CP-201000251  
Log # TXNB-10013

**SUBJECT:** COMANCHE PEAK NUCLEAR POWER PLANT, UNITS 3 AND 4  
DOCKET NUMBERS 52-034 AND 52-035  
RESPONSE TO REQUEST FOR ADDITIONAL INFORMATION REGARDING THE  
ENVIRONMENTAL REVIEW AND SUPPLEMENTAL INFORMATION FOR  
PREVIOUS ENVIRONMENTAL QUESTIONS

### **Response to Request for Additional Information Regarding the Environmental Review**

**PRELIMINARY**  
**MAKEUP WATER INTAKE STRUCTURE**  
**GENERAL PLAN**

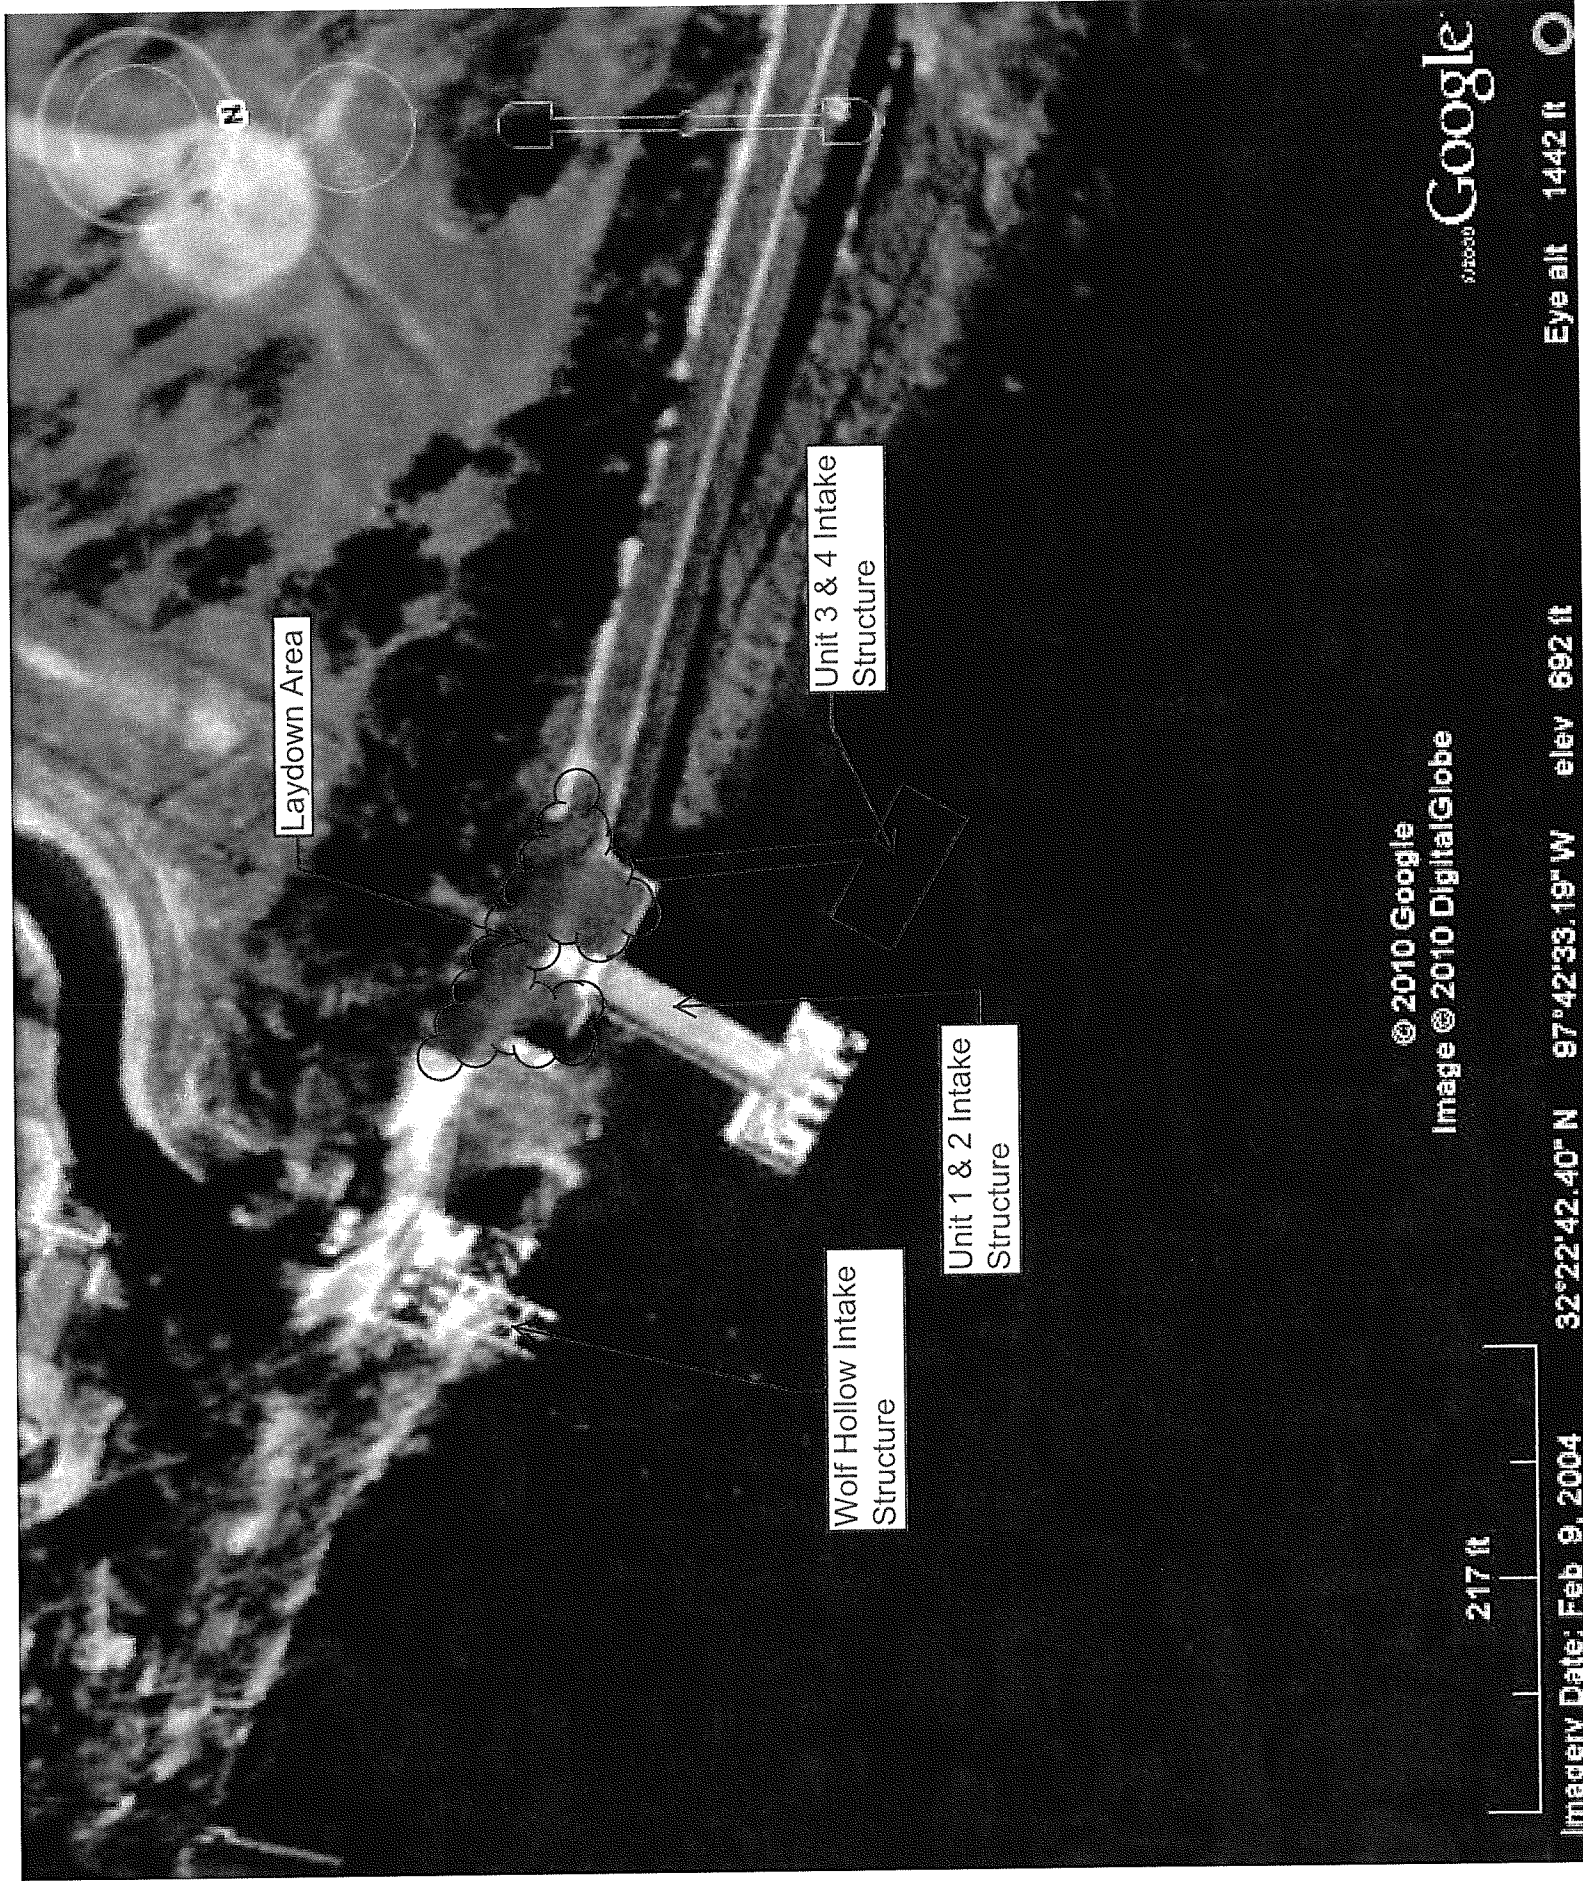
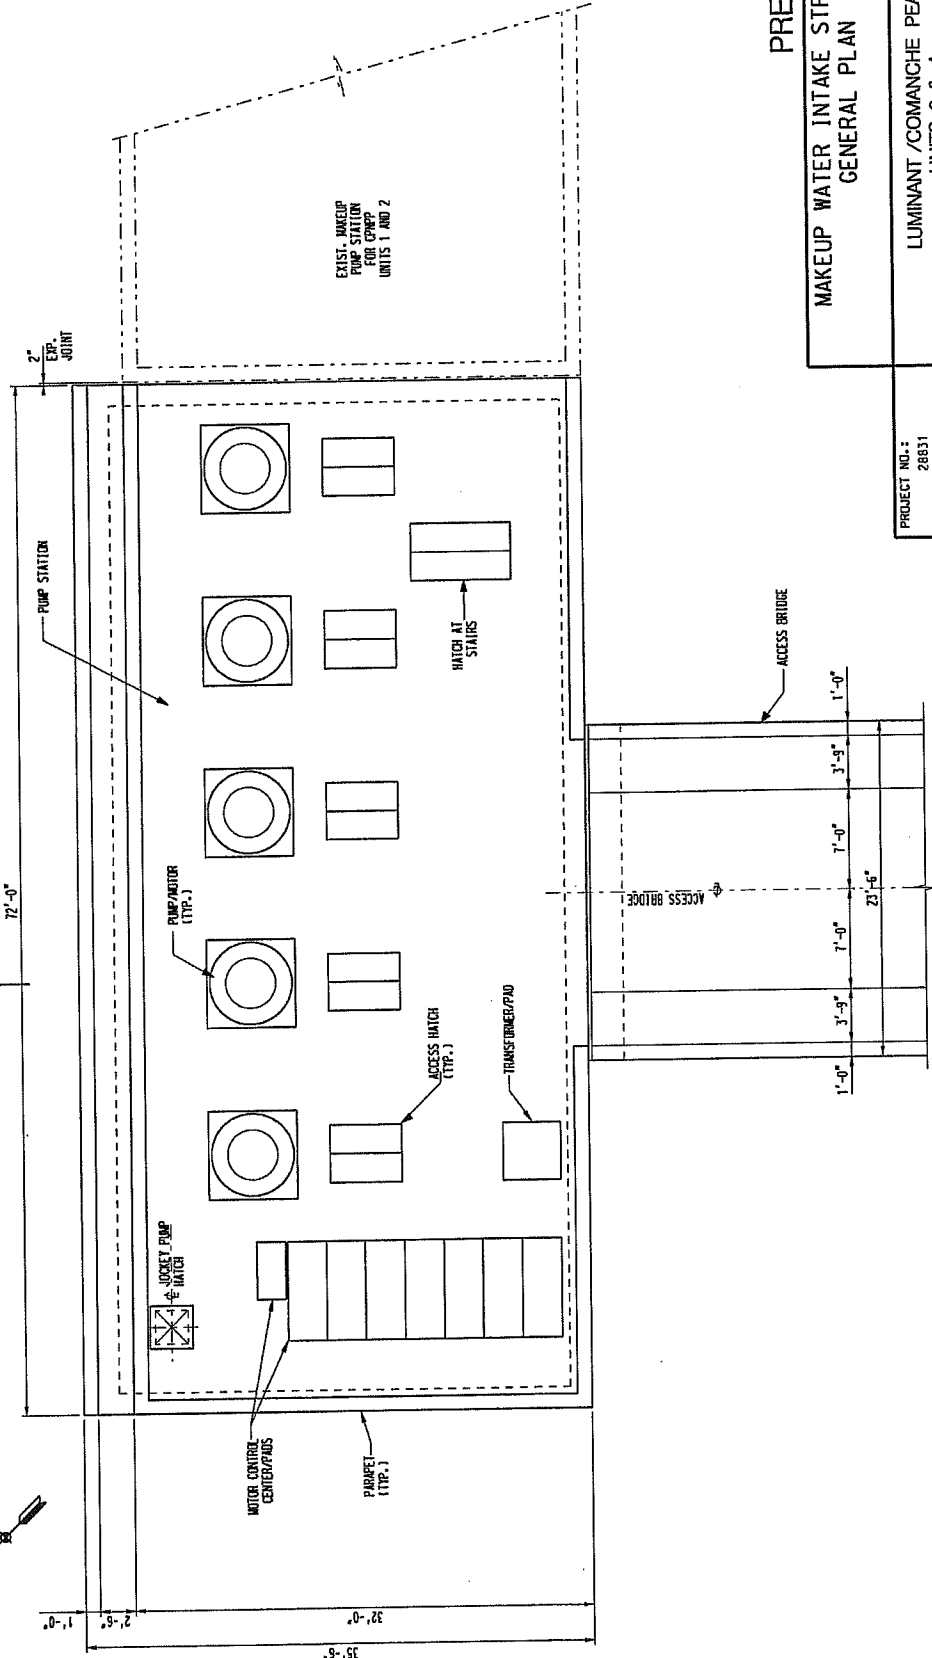
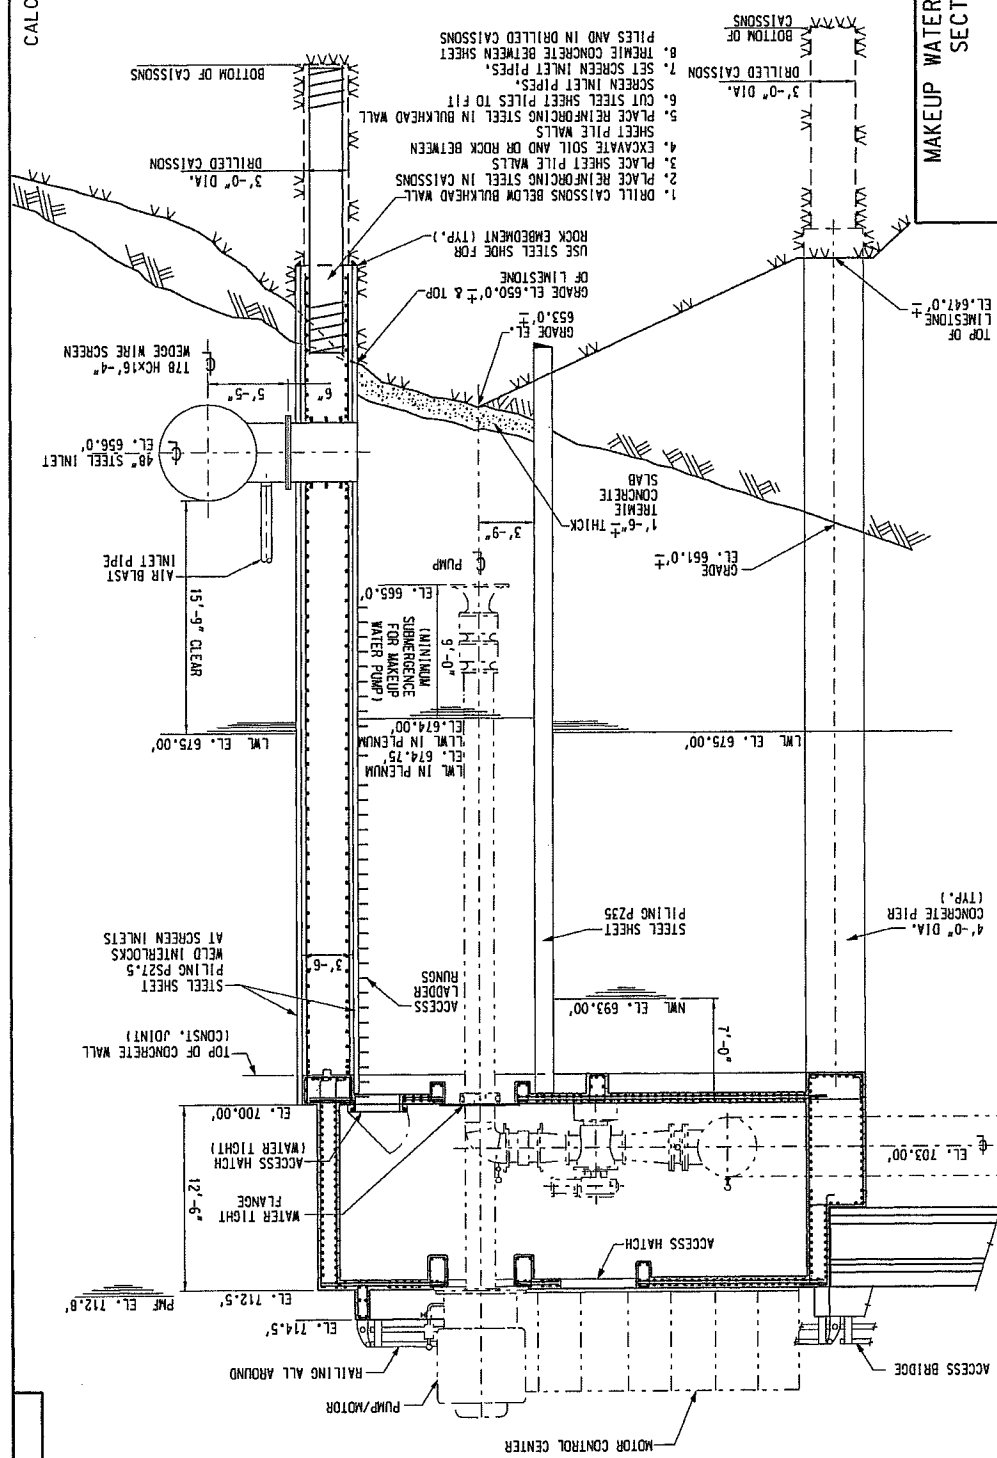
Provide a figure that shows the exterior dimensions of the intake structure with reference to the existing intake and other man-made structures in the immediate vicinity, and displays both the areas that would be disturbed during construction and areas permanently committed to the intake.

Based on the current preliminary design of the Makeup Water Intake Structure and return piping, it is expected that construction of the intake structure and return will take 12 to 18 months. It is not expected to require the installation of cofferdams. Dredging is also not expected other than the collateral movement of loose surface material as a result of drilling. Drilling into the rock is required to install the caissons and sheet piling that make up the foundation and boundary of the intake structure. No material is expected to be removed. This minimal disturbance will occur around the immediate periphery of the intake structure, estimated to be 80 feet long and 40 feet wide, nominally, or approximately 3,200 ft<sup>2</sup>. The Units 3 and 4 Intake structure is adjacent (to the west) of the Units 1 and 2 Intake Structure. The Wolf Hollow intake is located about 200 feet further downstream from the Units 1 and 2 intake. The nearest boat docks are several hundred feet away from this site.
